REGULATION 4 OF THE INFRASTRUCTURE PLANNING (CHANGES TO, AND REVOCATION OF, DEVELOPMENT CONSENT ORDERS) REGULATIONS 2011 APPLICATION TO MAKE A NON-MATERIAL CHANGE TO THE OAKLANDS FARM SOLAR PARK ORDER 2025 (SI 2025/739) AS CORRECTED BY THE OAKLANDS FARM SOLAR PARK (CORRECTION) ORDER 2025 (SI 2025/1070)

EN010122 – Oaklands Farm Solar Project Non-Material Change Application.

Interested Party Reference number: 20047649

Amy Wheelton Independent Seales South Derbyshire District and Linton Division Derbyshire County Councillor

nsip-documents.planninginspectorate.gov.uk/published-documents/EN010122-000819-EN010122 D7 6.1 ES Chp8 Appx 8.1 Flood Risk Assessment and Outline Drainage Strategy Clean.pdf

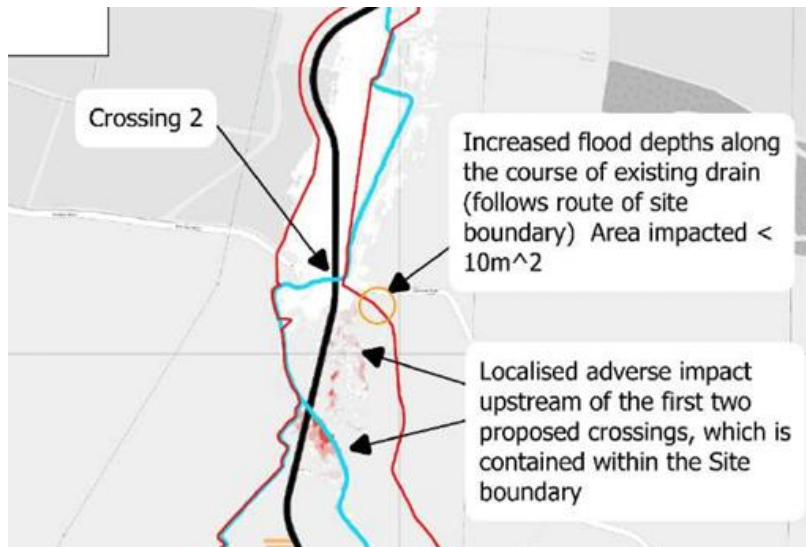
Please note for all these conditions it does not fulfil the requirements of the Development Consent Order (DCO) in that the submitted details do not “include the plans and strategies referred to in the flood risk assessment” as required by Requirement 17 part 2 of the DCO as they are not in accordance with the flood risk assessment which shows clearly land near Rosliston road may flood by up to 20cm. Please refer to FRA document dated Dec 2024.

Event	Off-site land at increased flood depths (m ²)	Off-site land at decreased flood depths (m ²)	Maximum increase in flood depths off-Site (m)
3.33% AEP	10	224	0.20 (Within existing ditch along Site boundary – covering area less than 7m ²) Floodplain – no increase
